Central Connecticut State University

| NUMBER | DATE | DESCRIPTION |
|---|---|---|
| #1 | 11/01/13 | HAMMER/DISCUSS CAGE |

# BARBOUR ROAD FIELD

HAMMER/ DISCUS CAGE PLANS, DETAILS AND NOTES

2 / C-1 HAMMER/ DISCUS CAGE ELEVATION
SCALE: 1/4"=1'-0"

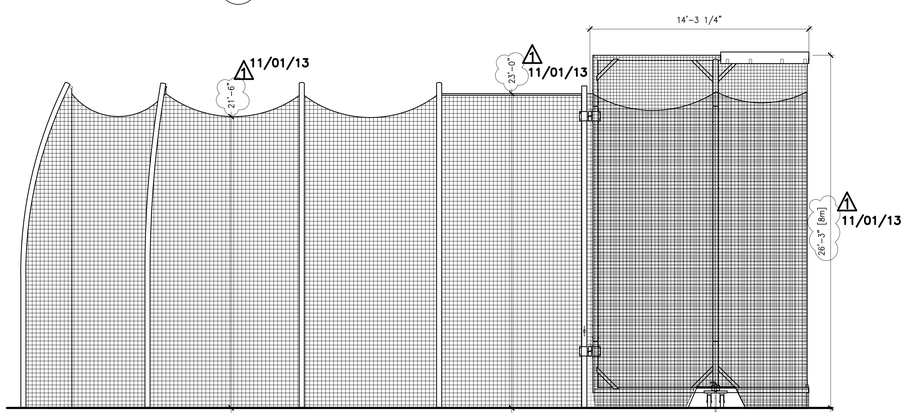
11/01/13 The 732205, NCAA Double Ring Hammer/Discus Cage by Gill Athletics, consists of eight rolled aluminum net poles, two galvanized steel door hinge poles, and two aluminum movable doors. Per NCAA rules, net is supported at full cage height between the door poles and first net support poles. A ground sleeve kit model # 73220501 and a Hammer Cage Door Bracing model # 732104 should also be supply and installed by manufacturer's recommendation.

| NUMBER | DATE | DESCRIPTION |
|---|---|---|
| | | TALL MODEL: 26'-3" (8m) |
